**Town of Rotterdam
Planning Commission
December 16, 2025**

DPW Comments
December 16, 2025

**RE: TDE Review – 759 Peter Road Apartments
759 Peter Road, Rotterdam, NY**

CONCEPT PLAN

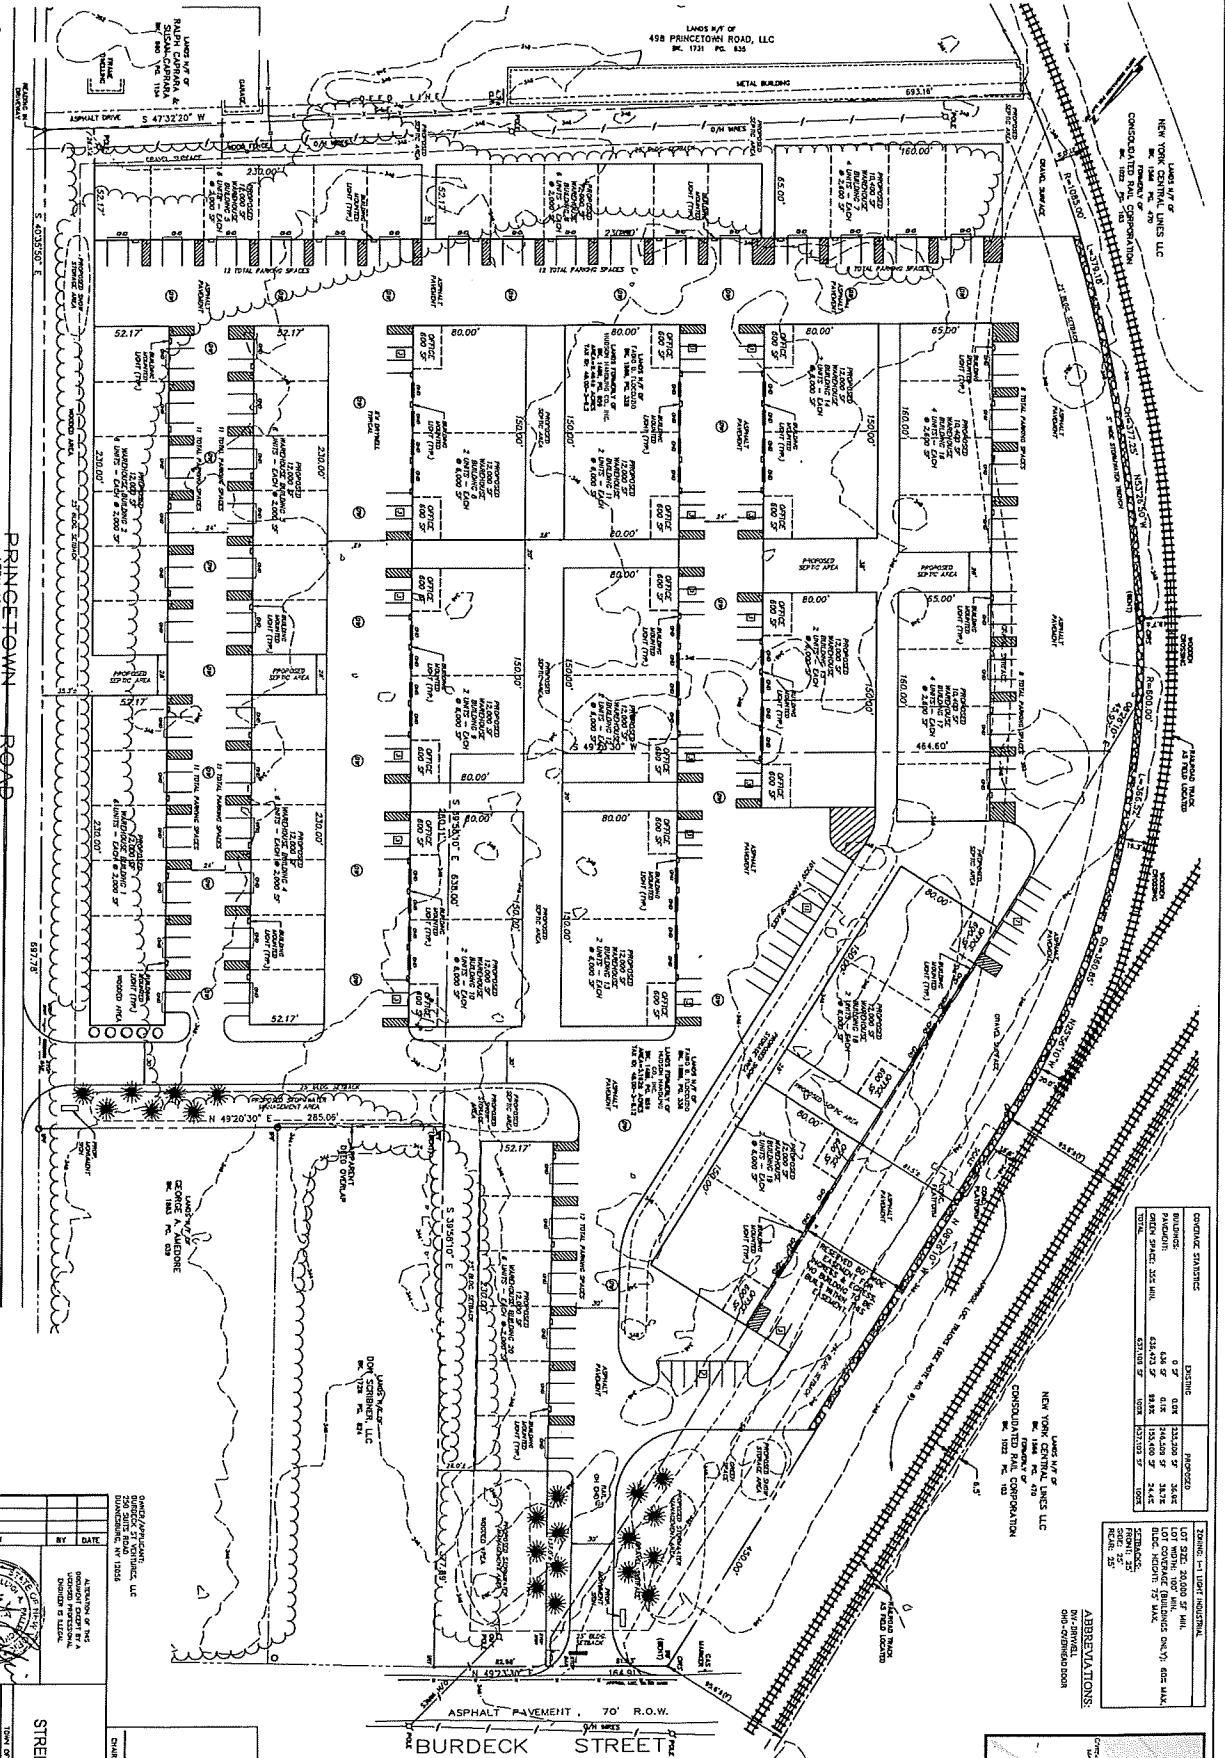
1. Project has been modified substantially and more than doubled in size. Proposed square footage of buildings has increased from nine (9) buildings and 108,000 square feet to twenty (20) buildings and 235,200 square feet. Lot coverage should be calculated and addressed. Building separation and snow storage may be problematic.

2. Provide a phasing plan.
3. Proposed multiple tenancy per building with unknown users makes parking allowance and utilities very difficult to review.
4. Proposed water supply should be looped throughout the site and from Burdeck and Princetown Roads.

5. Fire department access and hydrant locations should be addressed.
6. Proposed drywell system may not be adequate given the amount of impervious surfaces.

7. Access onto Princetown Road and Burdeck Street should be discussed. Turn lanes may be necessary given the proposed density. Traffic study will need to be amended to include additional warehouse space.

BUILDING ELEVATIONS

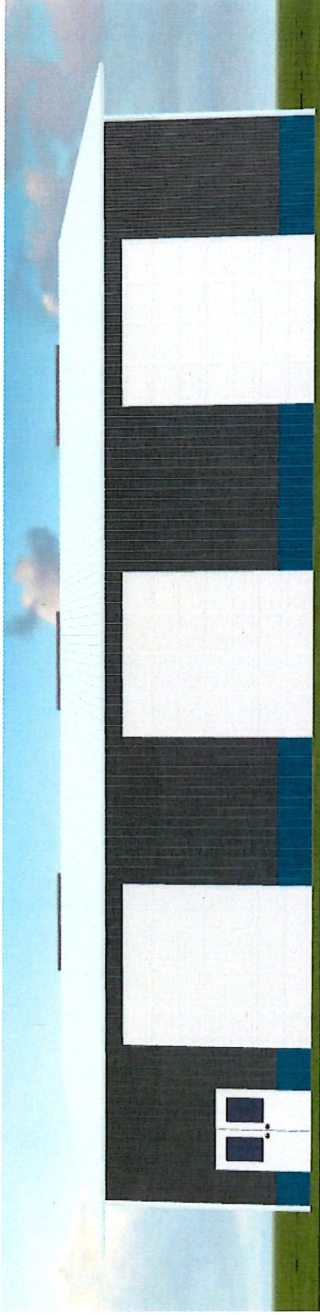
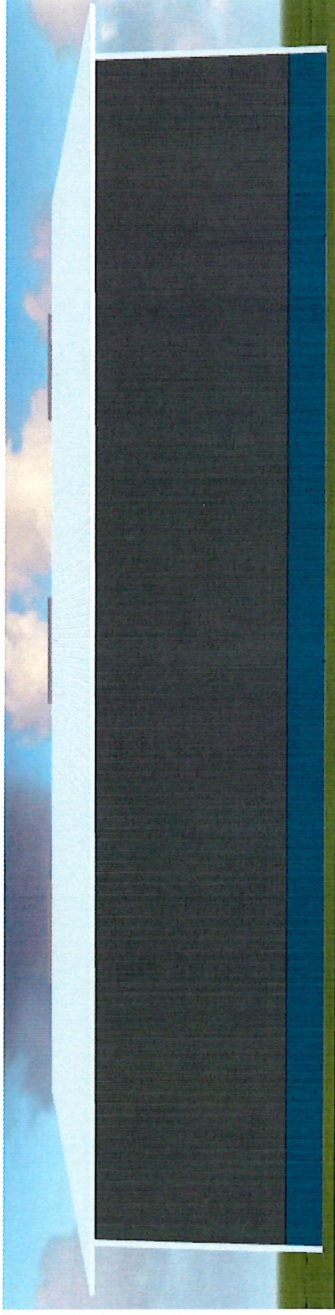
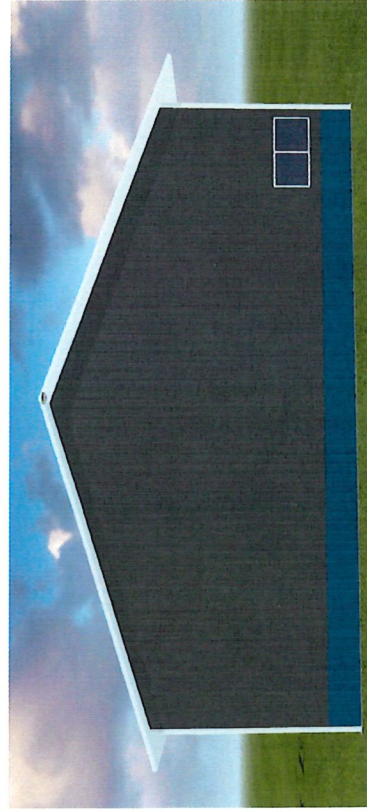
10. Modify note #9 on plan: "Building design shall be in substantial conformance to the proposed Exterior Elevations presented to the Planning Commission on December 16, 2025."

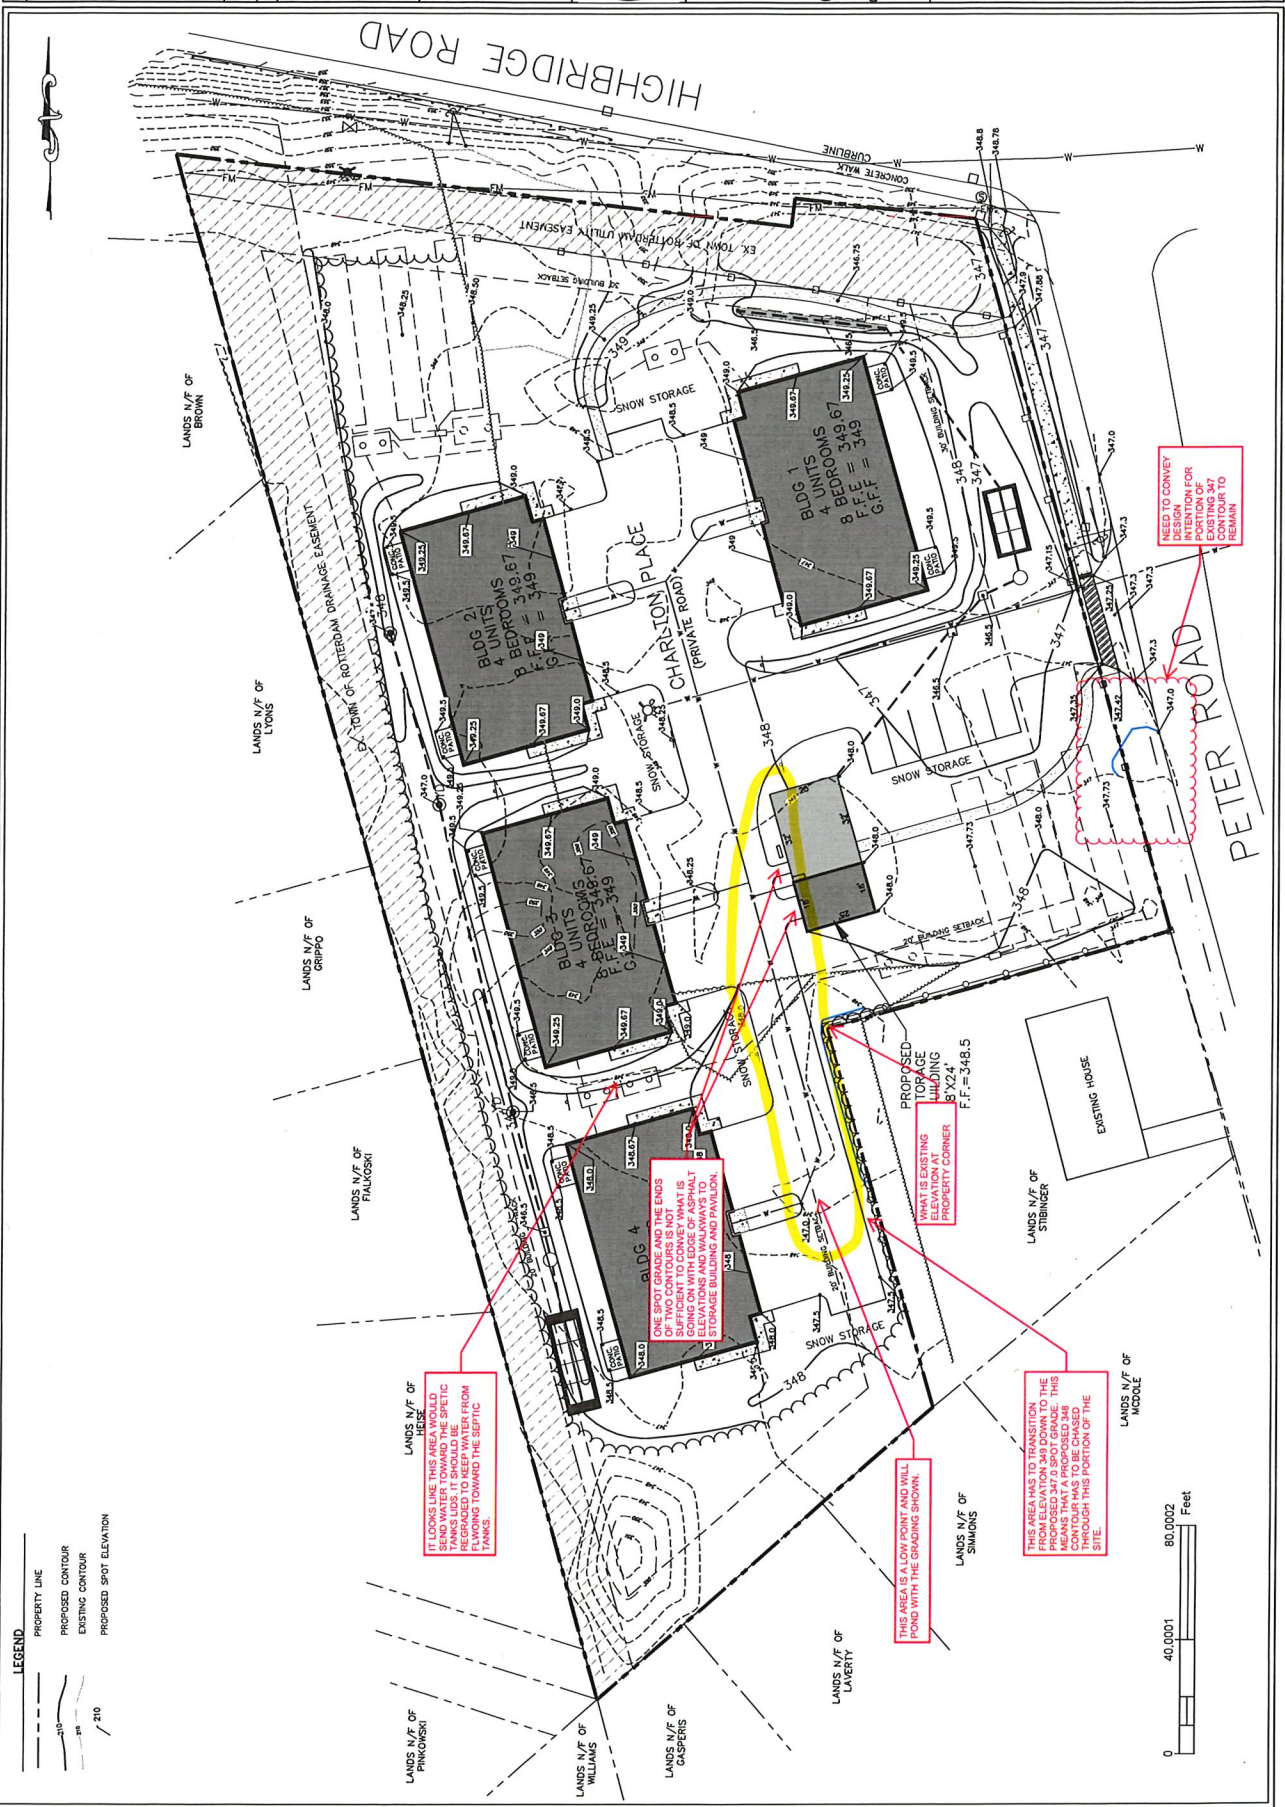
1. A grading plan with markups has been attached to this comment letter to specifically highlight the areas where there still appears to be conflicting or unconventional contour information. These areas should be reviewed and updated appropriately.

RESPONSE: *The grading plan has been reviewed with the mark ups and modified accordingly.*
CLARIFICATION: There are still a few areas of the grading that need to be modified. See attached grading plan markup with comments.

Several revisions to the grading plan have been made in accordance with the red-lined mark plan provided.
